No. 92-19

A. TORSIONAL (CRANKSHAFT) DAMPER BOLT TORQUE CHANGE

262 CID (4.3L), 305 CID (5.0L), 350 CID (5.7L) Engines.

Figure 1.

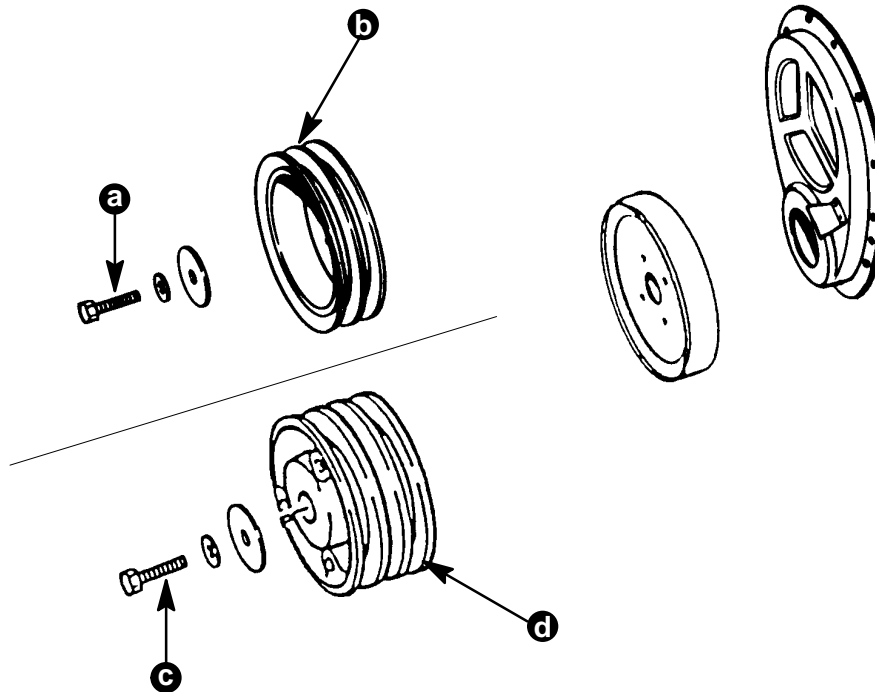
There are two different grade attaching bolts for the torsional (crankshaft) damper. One bolt, P/N 10-72626, is 2-1/4 in. (57mm) long and is used when a stamped steel pulley is used on the damper. The other bolt is 2-1/2 in. (64mm) long and used when the cast aluminum pulley is used, Figure 1. Please make the following change to your Service Manuals.

#7 V6 Engine Service Manual 90-12410, page 3B-1: Cross out torque shown for Torsional Damper, add:

#9 V8 Engine Service Manual 90-14499--1, page 3A-1: Cross out torque shown for Crankshaft Pulley, add:

Stamped steel pulley – 60 lb. ft. (81 N-m)

Cast aluminum pulley – 40 lb. ft. (54 N-m)

Stamped steel pulley – 60 lb. ft. (81 N-m)

Cast aluminum pulley – 40 lb. ft. (54 N-m)

- a - 60 lb. ft. (81 N-m)
- b - Stamped Steel Pulley
- c - 40 lb. ft. (54 N-m)
- d - Cast Aluminum Pulley
